Value Engineering Study

KY338 RECONSTRUCTION PROJECT AT I-71/I-75 BOONE COUNTY, KENTUCKY

VE STUDY NUMBER 201206

Draft Report

VALUE ENGINEERING RECOMMENDATION # VE-16
SKETCH OF RECOMMENDED DESIGN

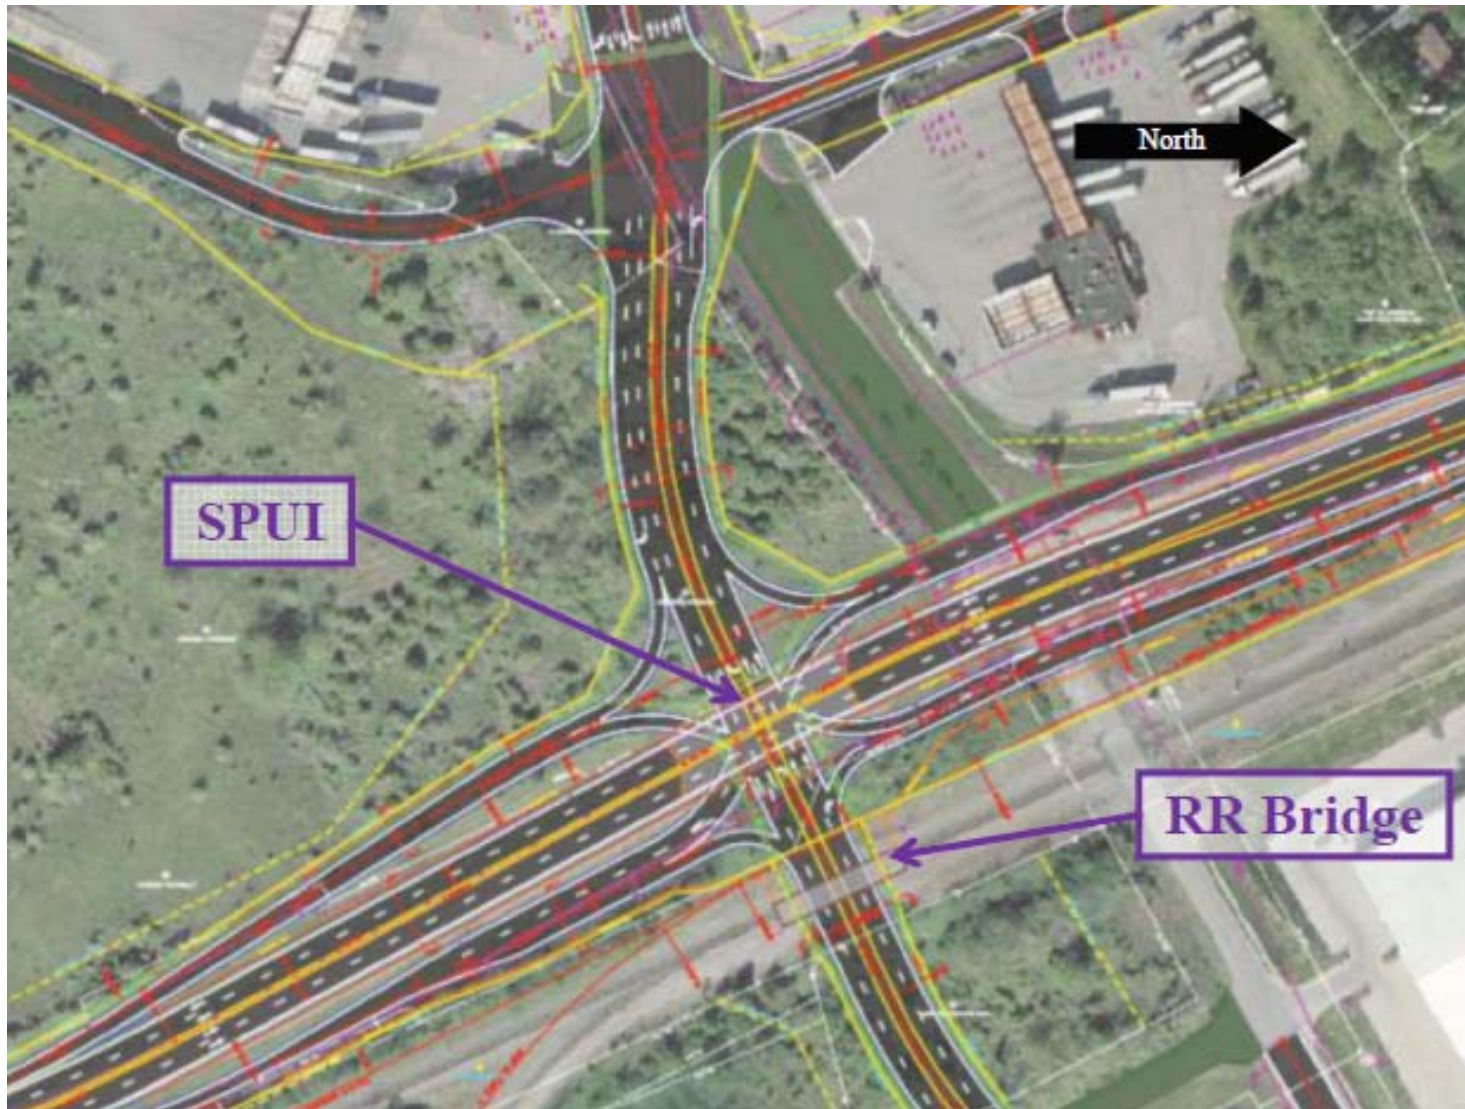
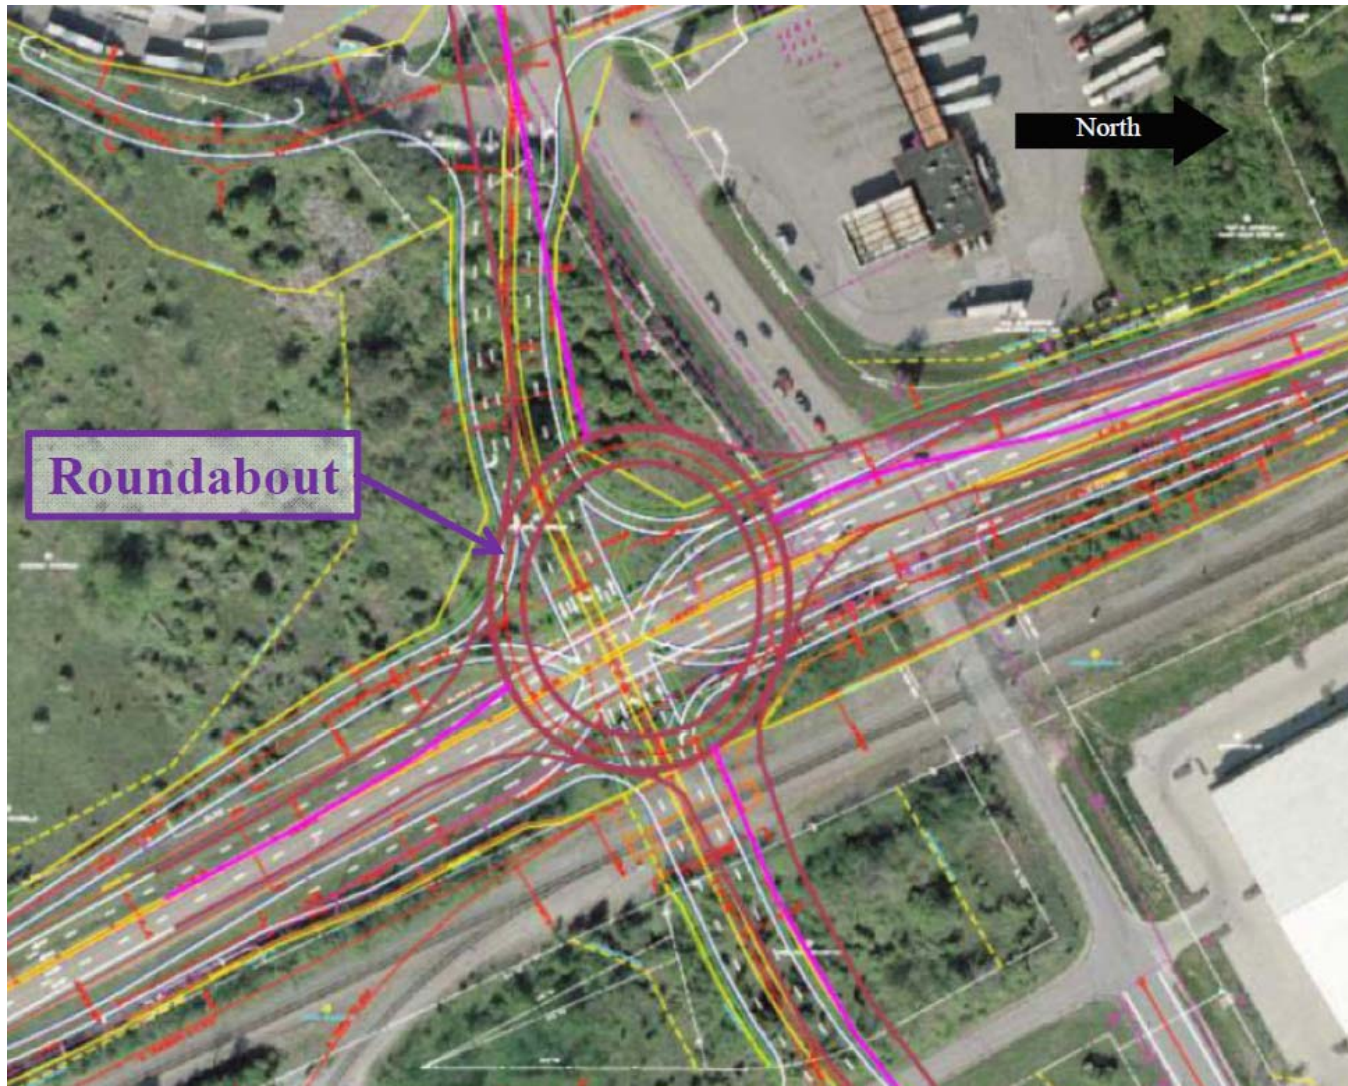
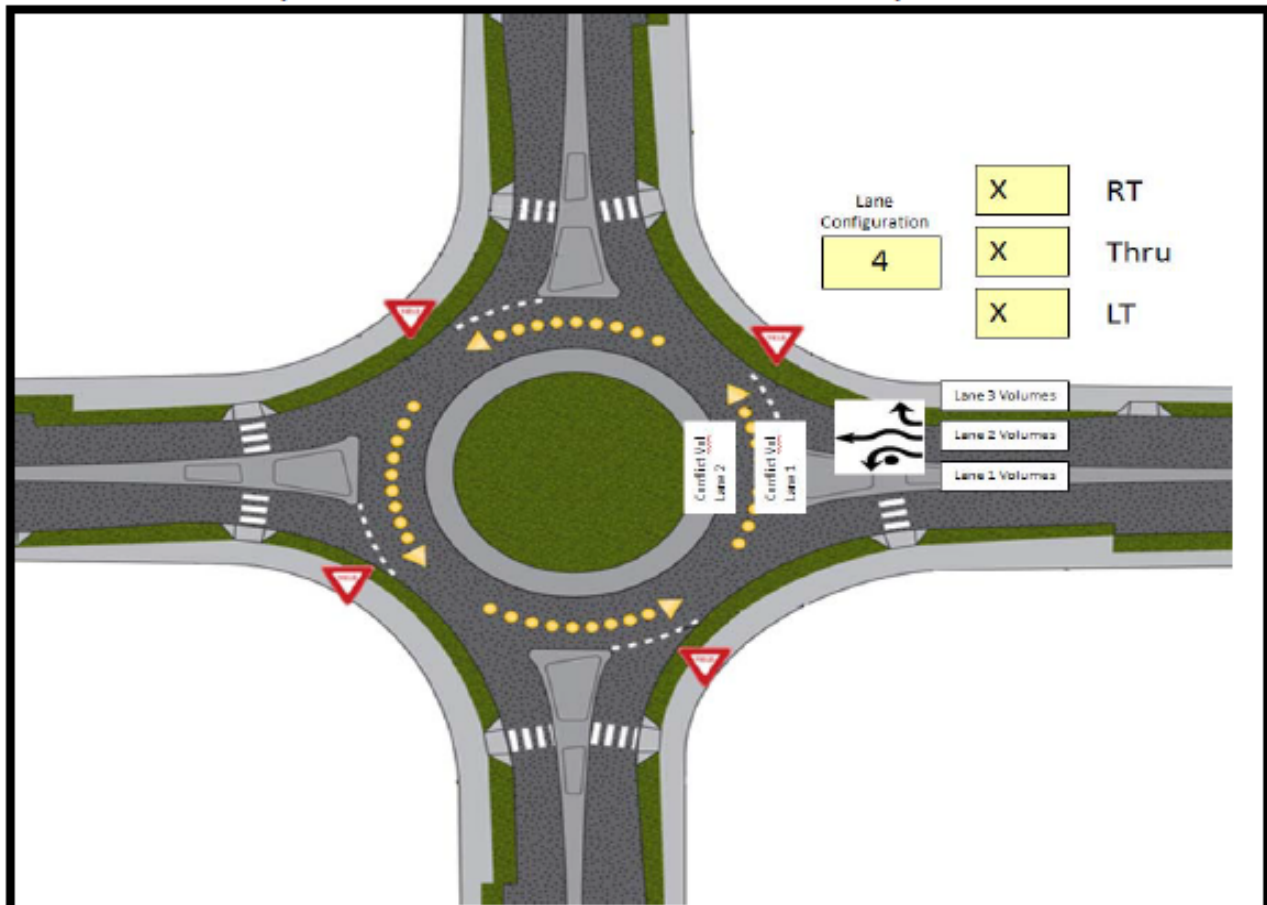
Roundabout Analysis: US 25 at KY 338; 2030 PM Peak Analysis

VALUE ENGINEERING RECOMMENDATION # VE-17

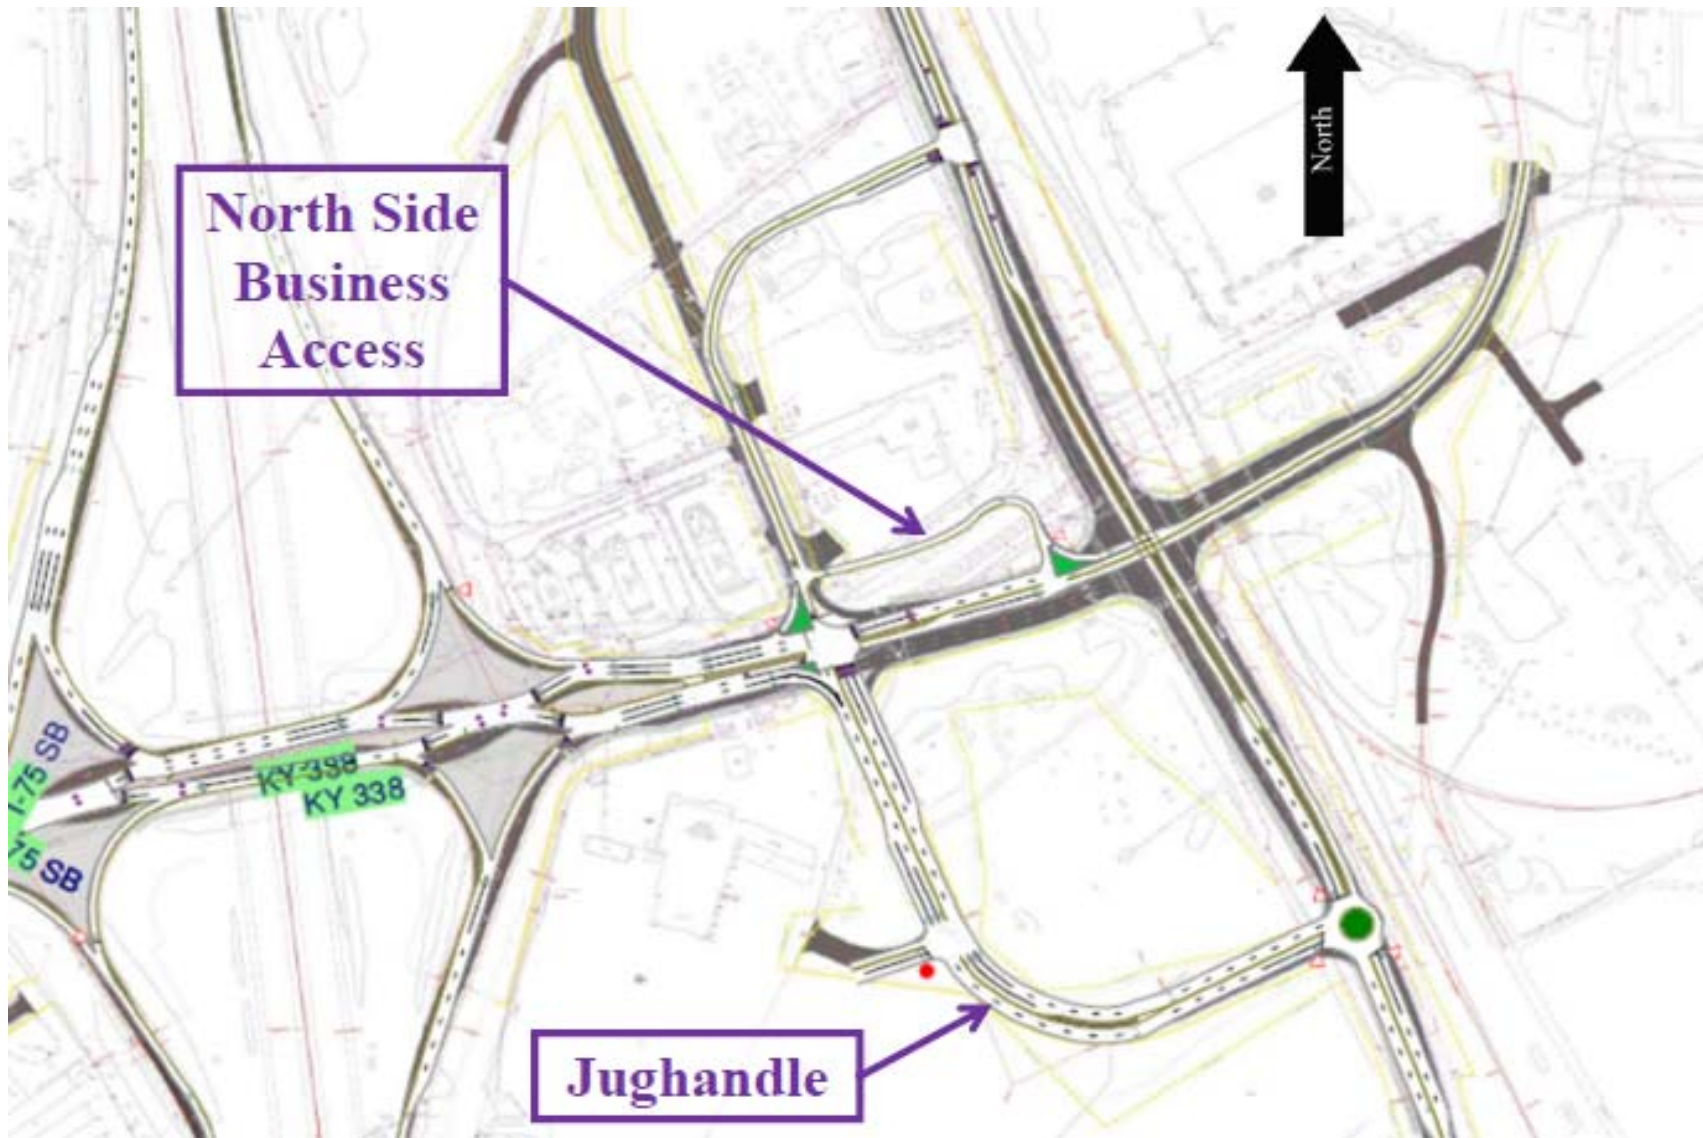
The close proximity of the railroad to the proposed SPUI requires a tight geometric design and the use of retaining walls to accommodate the grade separation of KY338 with US25 and the adjacent Railroad. Eliminating the need for ramps at the grade separation can significantly reduce retaining wall and structure costs associated with the design. Furthermore, the use of the jughandle/access road can provide direct access to the businesses on the north and south of the KY338 while handling the moderate volume of traffic traveling to/from US25. The implementation of the redirected left turns at Best Pal Drive provides the ability to operate the signal with only two phases, reducing associated delay at the intersection. The major movement to US25 can also operate as a continuous flow movement with minimal delay and queuing.

VALUE ENGINEERING DESIGN COMMENT # VE-23

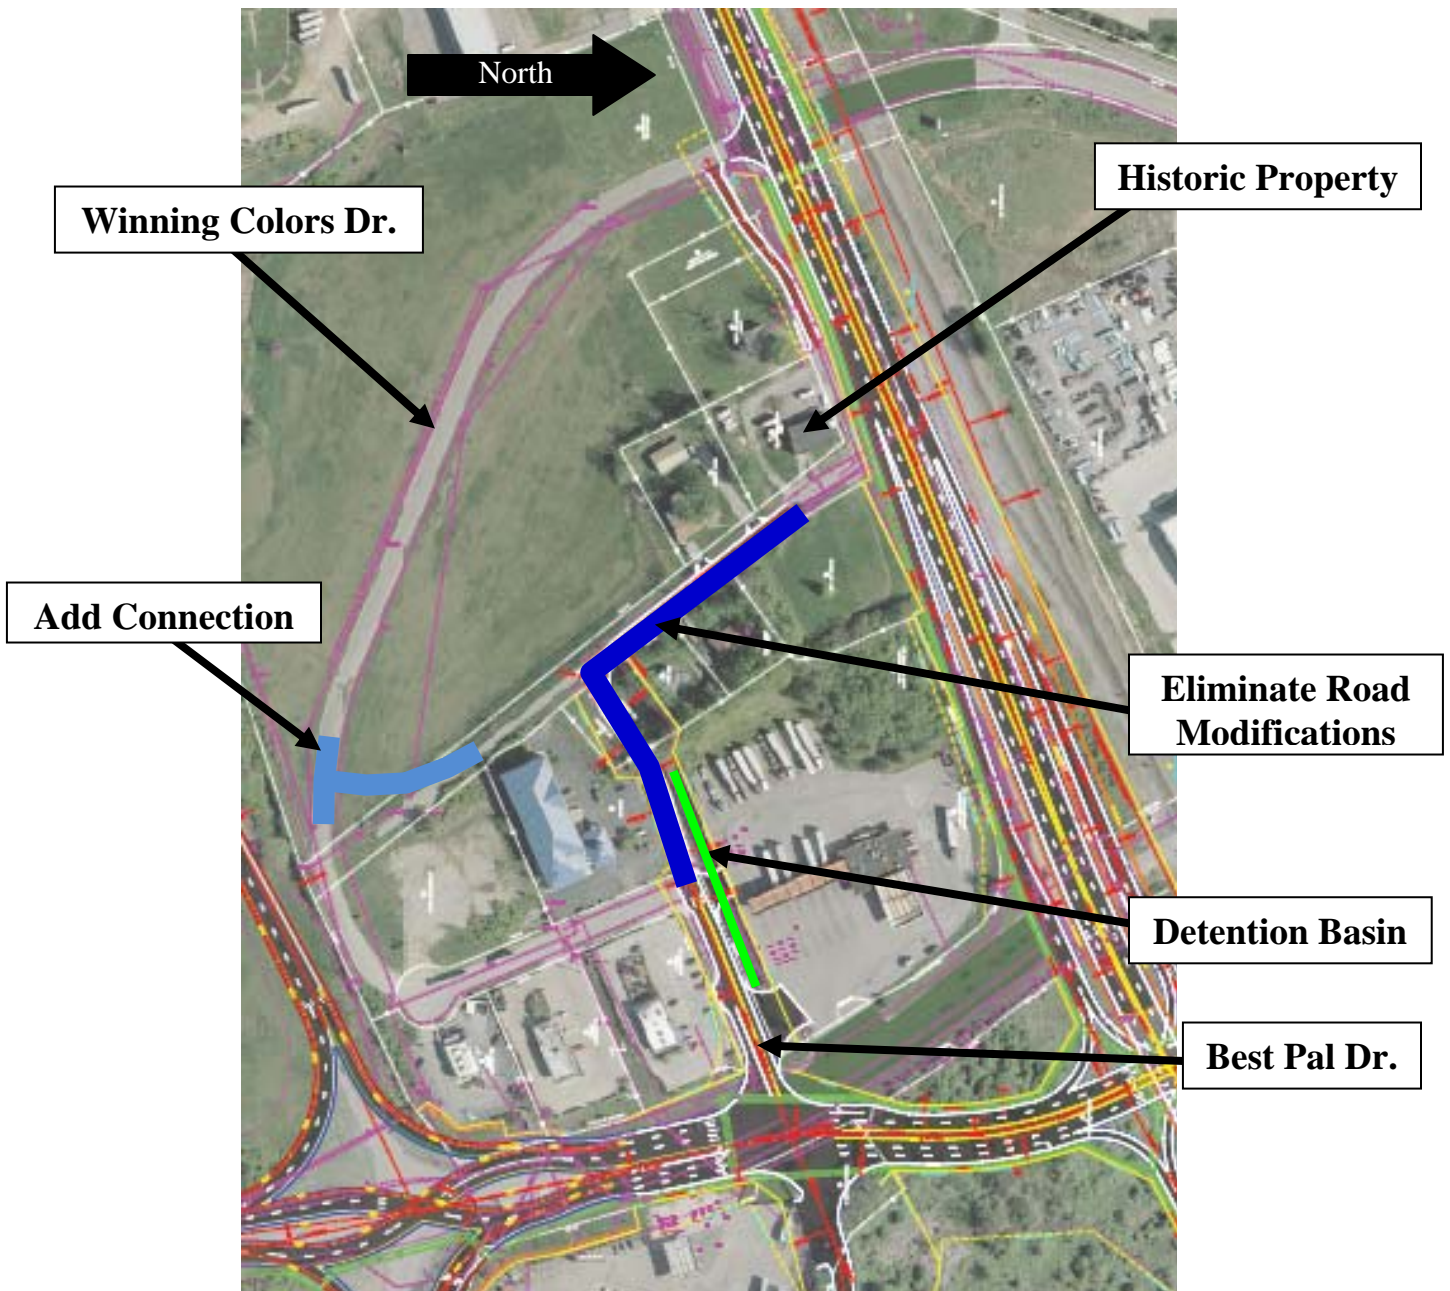
The VE recommends closing Richwood Road just west of the US25 intersection during the construction phase in lieu of building the US25 interchange under traffic. This will expedite the construction of the interchange and enhance the safety for the workers and travelling public. A key component of this design comment will be the preparation of the Traffic Management Plan, particularly the public awareness campaign that will be required to get the word out to the businesses and public at large.

A signed detour route option could be KY338 to Frogtown Connector to access KY 536 and then turning right on US25 to gain access from the north. However, local traffic could access the east side of US25 by travelling on the existing roads immediately within the project area such as Best Pal Drive to Winning Colors Drive and then Shorland Drive.

VALUE ENGINEERING DESIGN COMMENT # VE-25

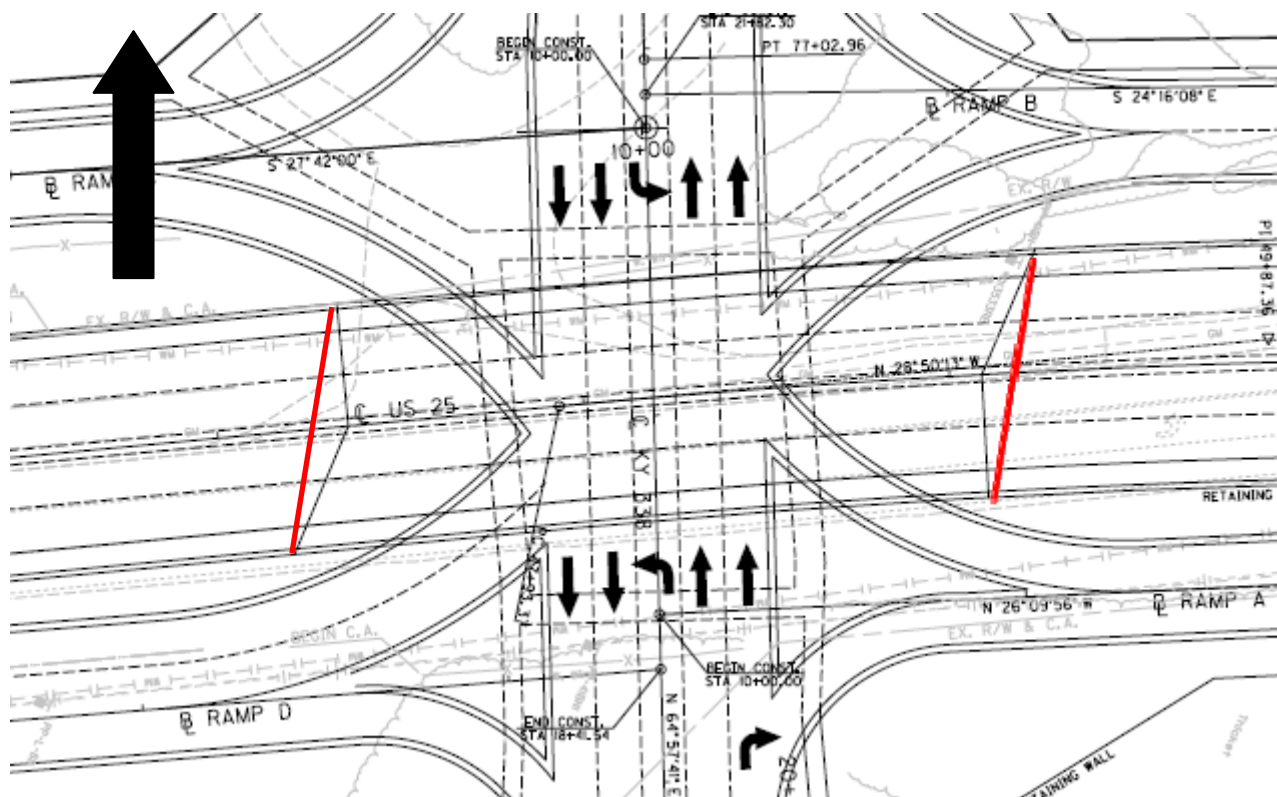
Verify railroad siding area, connection to US25, and associated earthwork are including in the project documents.

Just north of KY338, the Norfolk Southern Railway has a spur siding that has access to US25. If this project requires the removal of the spur or of its access to US25, then verify that the associated right-of-way cost is included and/or that if the replacement is included with this project that appropriate details and cost are included.
